SILVER / PETRUCELLI + ASSOCIATES

**N. STONINGTON BUILDING COMMITTEE
95% CD REVIEW COMMENTS**

North Stonington Center for Emergency Services
5/16/2015
MEP Sub-Committee

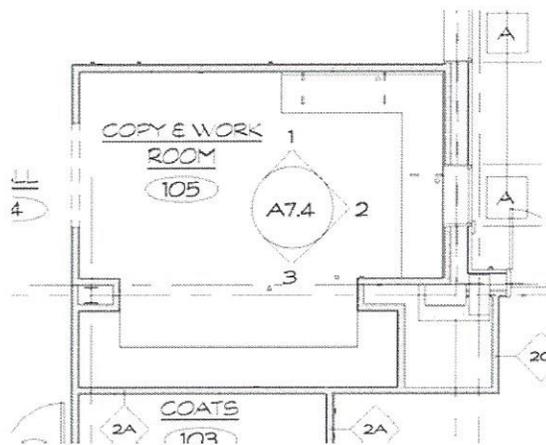
80. A1.0 Exterior Doors provide some type of rain protection over the door minimum 3ft x 3ft
80A. ARCHITECTS RESPONSE: SPA would advise against providing small canopies at all exterior doors for the following reasons;

- Canopies are already being provided at (2) main entrances as alternates, these are the main entries/exits
- Additional canopies of this size will increase construction cost without providing much benefit.
- Additional canopies will require P&Z review and approval

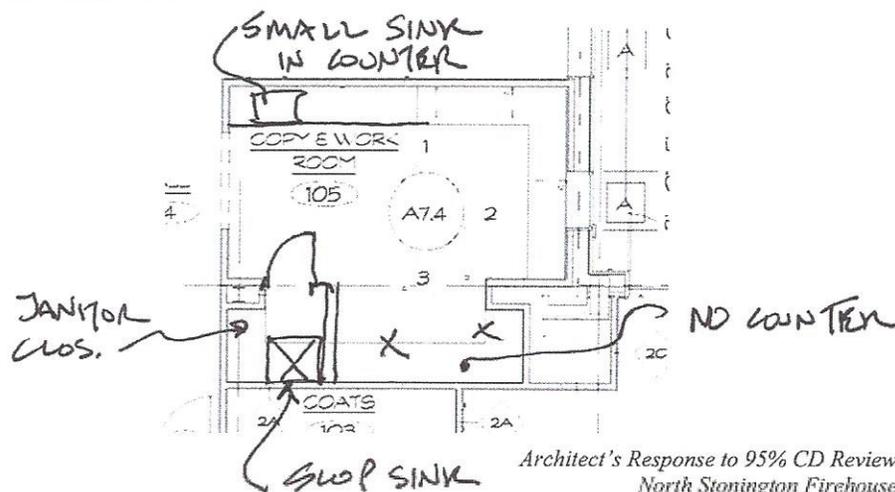
80. A1.0 Exterior Doors provide some type of rain protection over the door minimum 3ft x 3ft
80A. ARCHITECTS RESPONSE: SPA would advise against providing small canopies at all exterior doors for the following reasons;

- Canopies are already being provided at (2) main entrances as alternates, these are the main entries/exits
- Additional canopies of this size will increase construction cost without providing much benefit.
- Additional canopies will require P&Z review and approval
